Docket No. 50-416

FACILITY: Grand Gulf Nuclear Station, Unit 1

LICENSEE: Entergy Operations, Inc.

SUBJECT: SUMMARY OF NOVEMBER 6, 1990 MEETING REGARDING LICENSING ACTIONS

FIGURE 3.1.5-1 SODIUM PENTABORATE SOLUTION TEMPERATURE/CONCENTRATION REQUIREMENTS

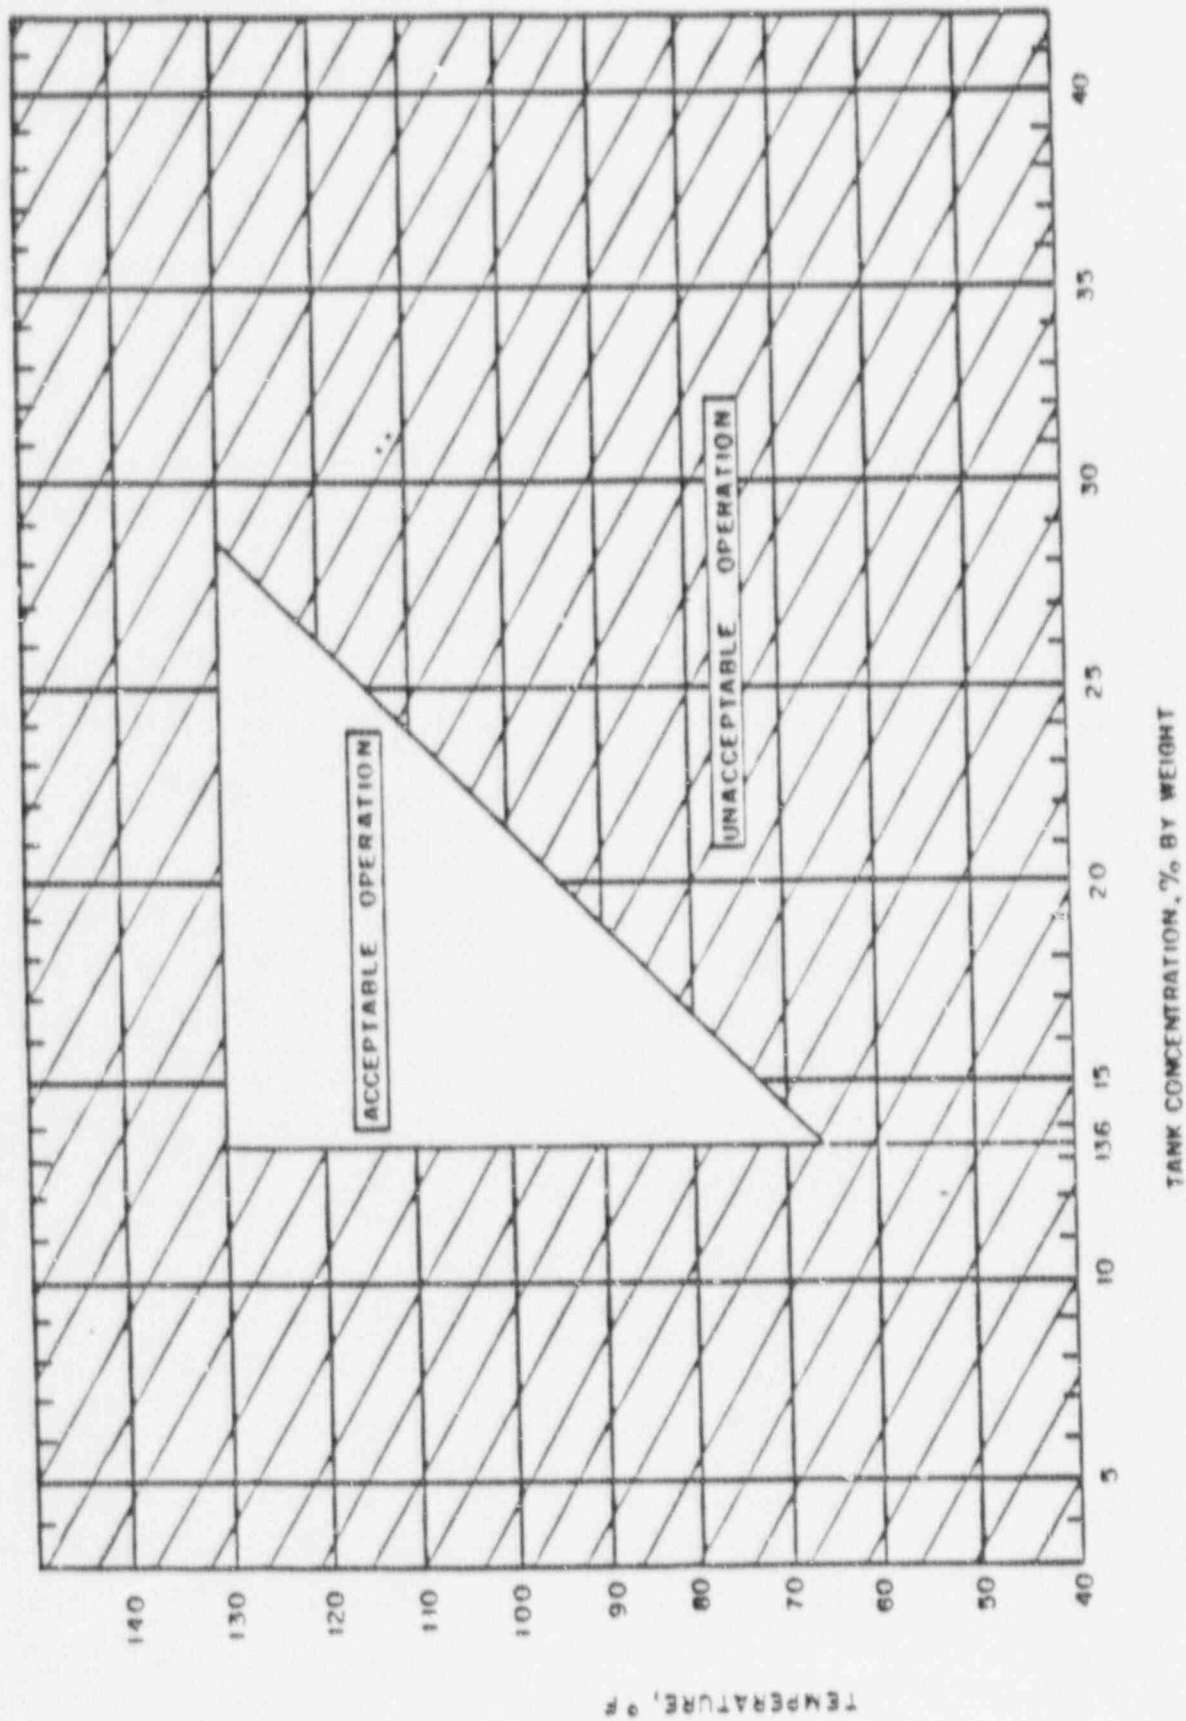
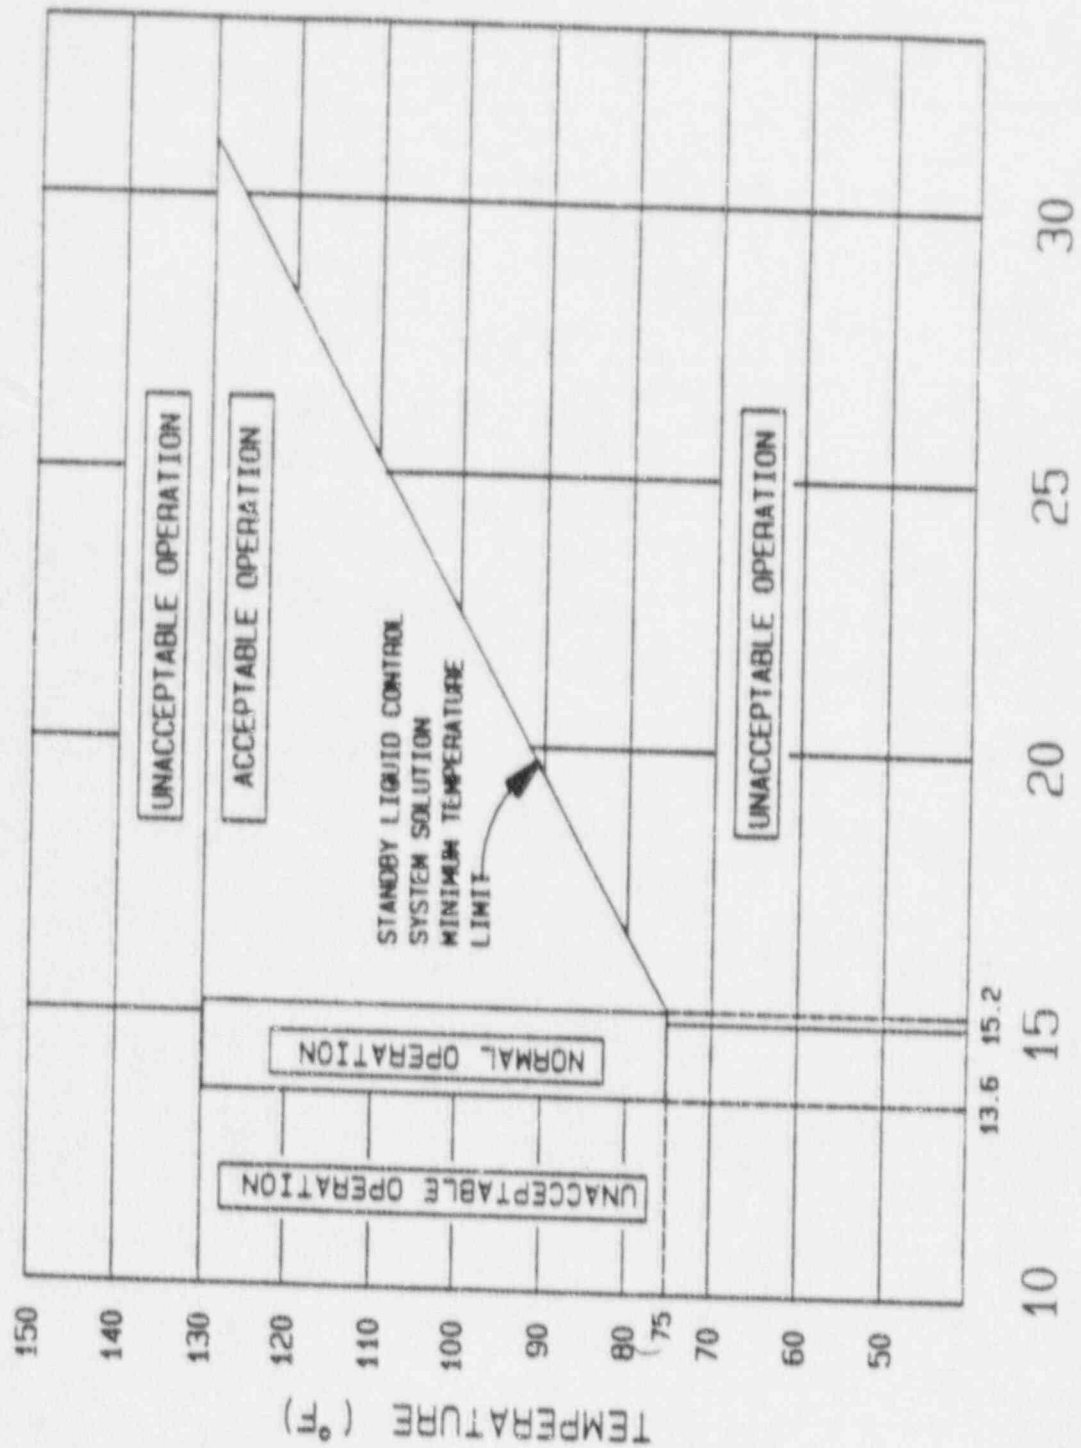
Proposed ACTION 3.1.5.d.1 and Figure 3.1.5-1 - Figure 3.1.5-1 should be changed to provide only the sodium pentaborate solution minimum temperature (saturation temperature plus a margin) versus concentration. The proposed ACTION should be changed to add the requirement that the solution temperature be raised above the minimum temperature of Figure 3.1.5-1 within eight hours if measurements show it to be less than the minimum temperature. In addition the allowed outage time for the solution concentration to be greater than 15.2% should be changed from 72 hours to 24 hours. An evaluation should be made to determine the maximum concentration

and minimum temperature to be allowed in the storage tank to assure that the required quantity of sodium pentaborate (5803 pounds) would be injected into the reactor, if SLCS is actuated when in the ACTION, taking into account precipitation in (1) the pump suction piping which is maintained at or above 75 degrees F by heat tracing, and (2) the pump discharge piping which is partly at the ambient temperature of the containment and partly at the ambient temperature of the drywell. The maximum concentration should be limited to a value that could be injected without excessive precipitation of the sodium pentaborate in the suction or discharge piping.

- o PROPOSED ACTION 3.1.5.d.1 AND FIGURE 3.1.5-1
 - CURRENT TECH SPEC FIGURE 3.1.5-1 ALLOWS WIDE RANGE OF TEMPERATURE VS. CONCENTRATION
 - PROPOSED FIGURE 3.1.5-2 RESTRICTS CONCENTRATION TO 13.6-15.2% IN A 75°F-130°F TEMPERATURE BAND
 - NARROWER CONCENTRATION BAND IS MORE DIFFICULT TO MAINTAIN
 - 13.6% IS ATWS LIMIT
 - 15.2% IS MINIMUM TEMPERATURE (75°F) PRECIPITATION LIMIT (70°+5° MARGIN)
 - CURRENT TECH SPEC ALLOWS 8 HOURS TO RESTORE CONCENTRATION TO ACCEPTABLE LIMITS OR PLANT SHUTDOWN REQUIRED

- PROPOSED ACTION AND FIGURE 3.1.5-1 ADDS ADDITIONAL RESTRICTIONS
 - TEMPERATURE SURVEILLANCE EVERY 4 HOURS VS. 24 HOURS
 - MUST RESTORE WITHIN 72 HOURS
 - SATURATION TEMPERATURE MARGIN MAINTAINED
- RESTRICTION OF 72 HOURS BASED UPON
 - DIFFICULTY OF RESTORING CONCENTRATION
 - SAFETY ANALYSES ALLOW UNLIMITED TIME
- GGNS PROPOSAL
 - RELABEL "ACCEPTABLE OPERATION" REGION TO "LIMITED OPERATION"
- NRC SHOULD APPROVE REQUEST AS REVISED

FIGURE 3.1.5-2
SODIUM PENTABORATE SOLUTION CONCENTRATION/AVAILABLE VOLUME REQUIREMENTS

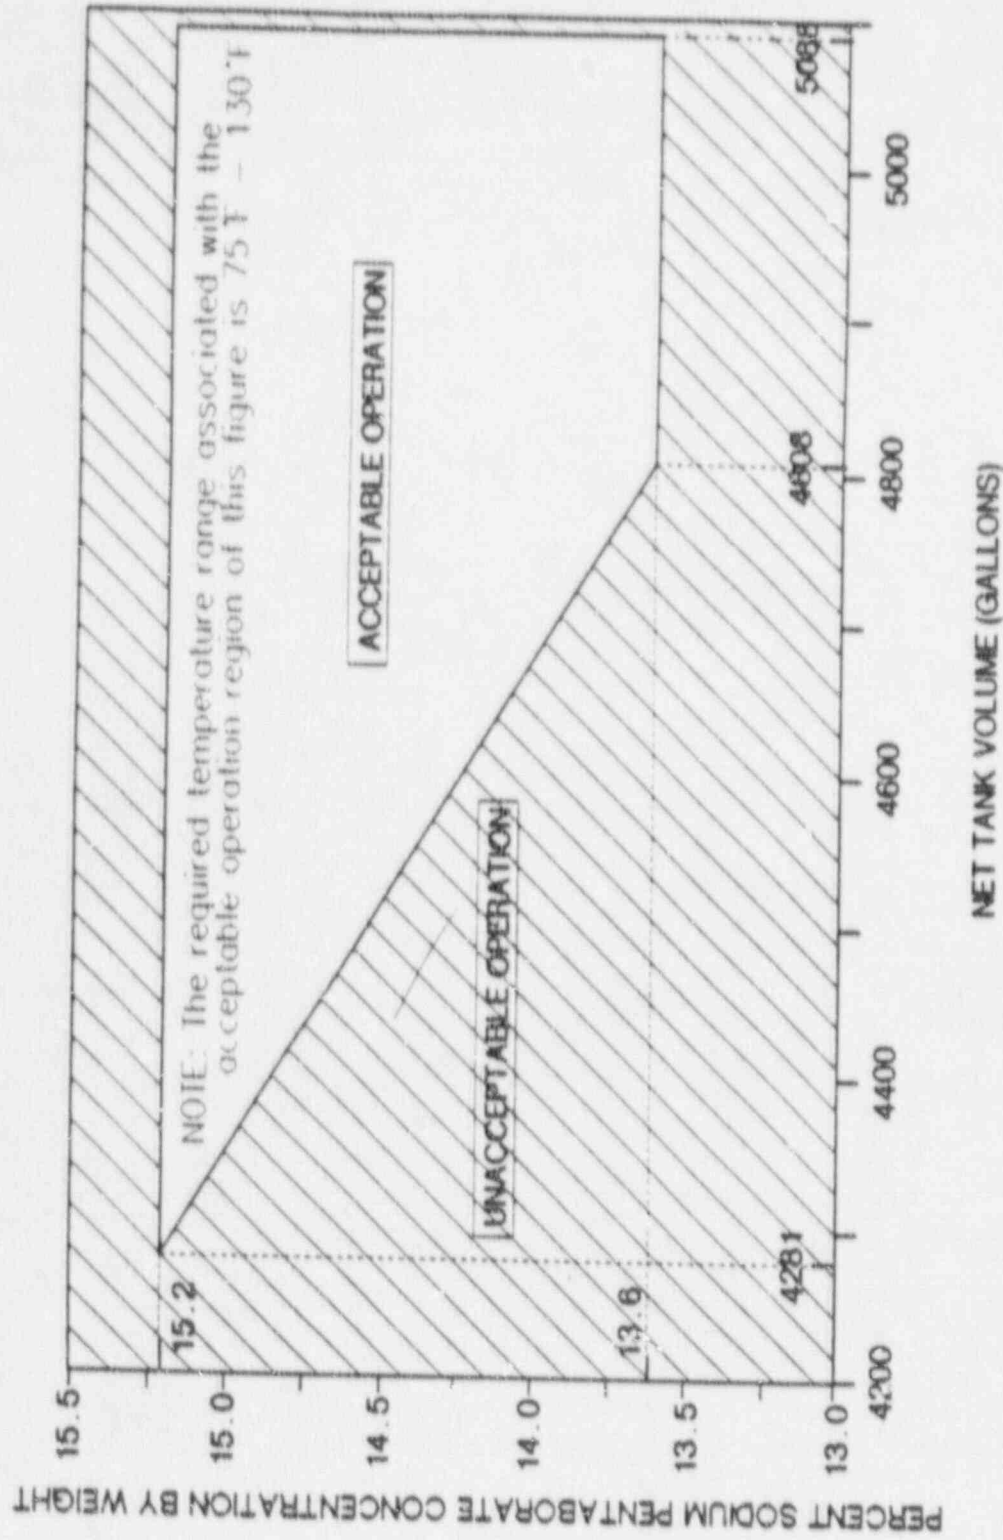
Proposed Figure 3.1.5-2 (Sheet 6, Enclosure 2) - Acceptable temperature range (75-130 degrees F) should be retained and the abscissa should be changed to read "NET TANK VOLUME BASED ON 90 degrees F."

- o PROPOSED FIGURE 3.1.5-2
 - CURRENTLY STATES TEMPERATURE RANGE OF 75°F-130°F
 - FIGURE BASED ON NOMINAL 90°F SOLUTION TEMPERATURE SPECIFIED BY GE DESIGN SPECIFICATION
 - LEVEL/VOLUME INSTRUMENTATION CALIBRATED TO 90°F NOMINAL SOLUTION TEMPERATURE
 - TEMPERATURE AFFECTS MINIMUM VOLUME REQUIRED
 - GGNS PROPOSAL
 - REMOVE 75°F-130°F NOTE FROM FIGURE
 - REVISE BASES TO STATE FIGURE BASED ON 90°F NOMINAL SOLUTION TEMPERATURE

Control Room Post-LOCA Doses

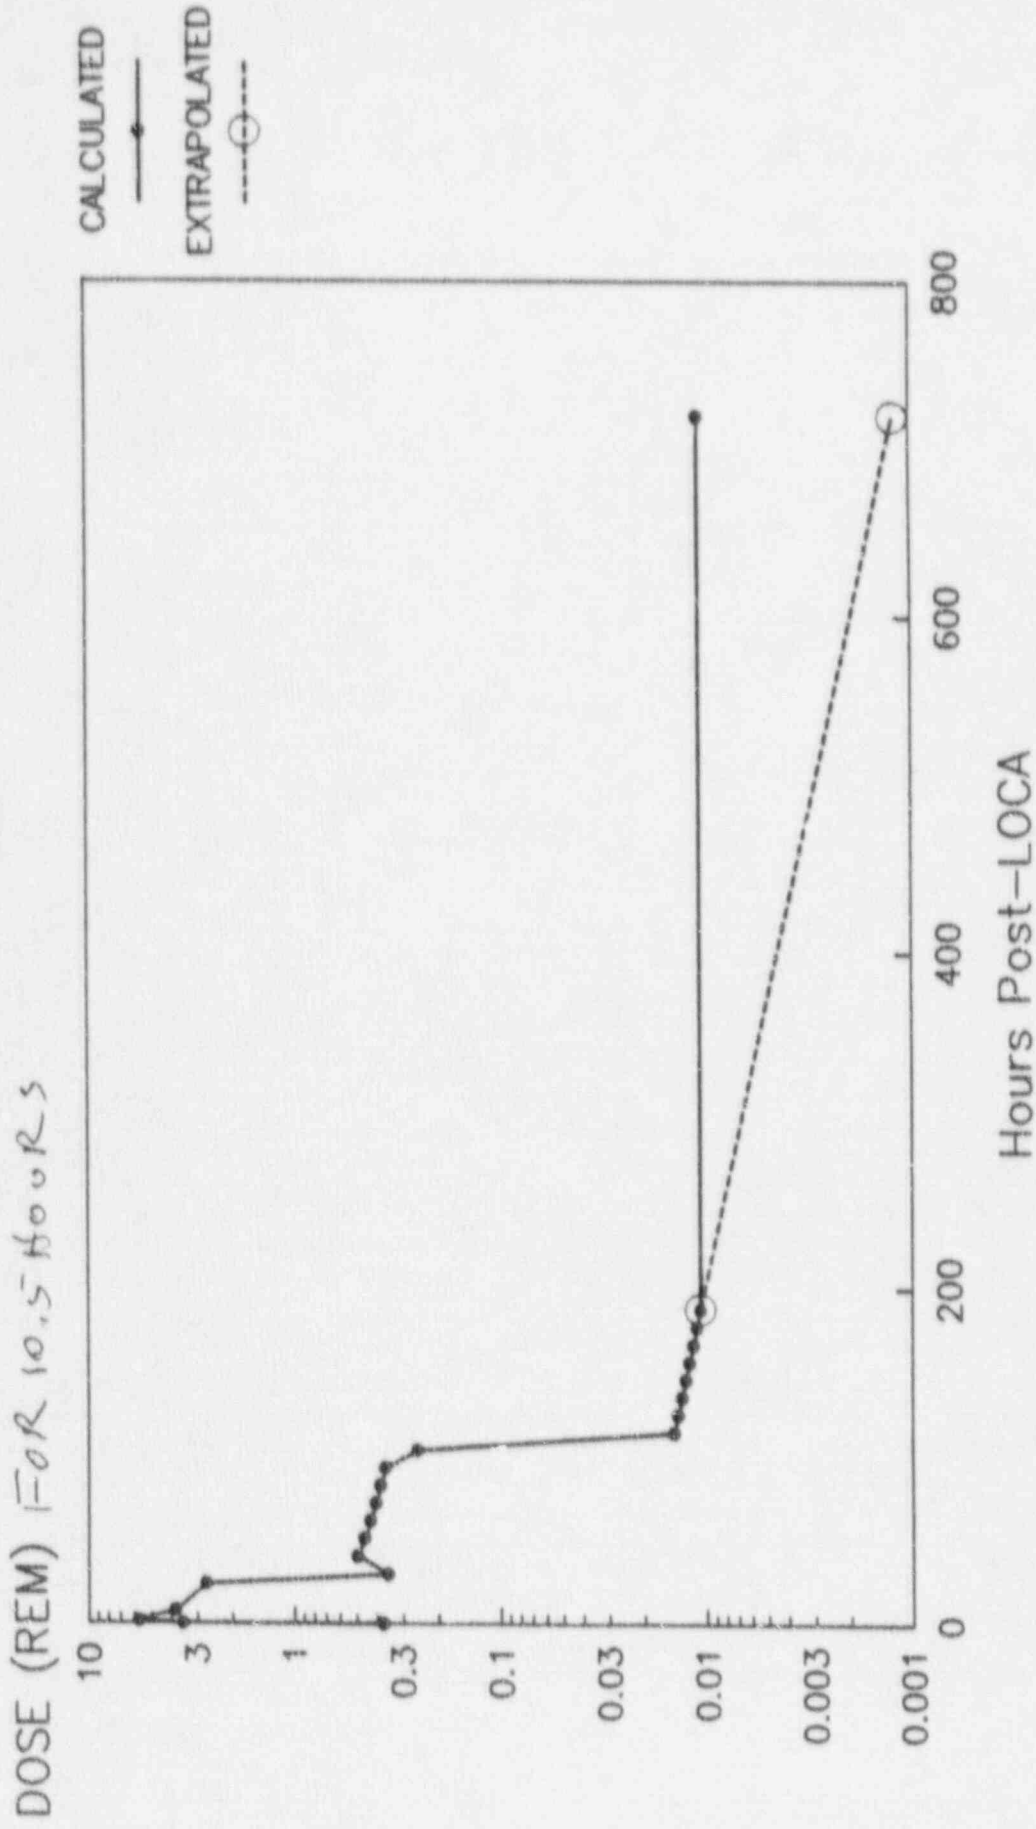
The licensee provided results of dose analyses assuming fresh air valves are open (Enclosure 2, Sheets 17 to 20). Results indicated that an intermittent or continuously open valve would result in control room doses less than the design basis case of unfiltered in-leakage.

- 40 TIME STEP LIMIT
- "WITH MAKEUP" CASE RUN FOR 187.5 HRS
- DOSE AT LAST TIME STEP ASSUMED CONSTANT THEREAFTER
- "WITHOUT MAKEUP" ALLOWS FOR DECAY/DISSIPATION THROUGHOUT 720 HR. PERIOD

- NO DECAY AFTER 187.5 HRS.
- MAKEUP STARTS AT 30 HRS. VS. 72 HRS. IN FSAR
- MAKEUP FOR A TOTAL OF APPROXIMATELY 32 HRS. COMPARED TO APPROXIMATELY 18 HRS. IN FSAR

The staff questioned whether leaving the present TS stand would not achieve the same result as the proposed change, since the licensee plans to change the Updated Final Safety Analysis (UFSAR) to delete the fresh air inlet valves from the table which presently lists them as isolation valves. The licensee will consider withdrawing the TS change request.
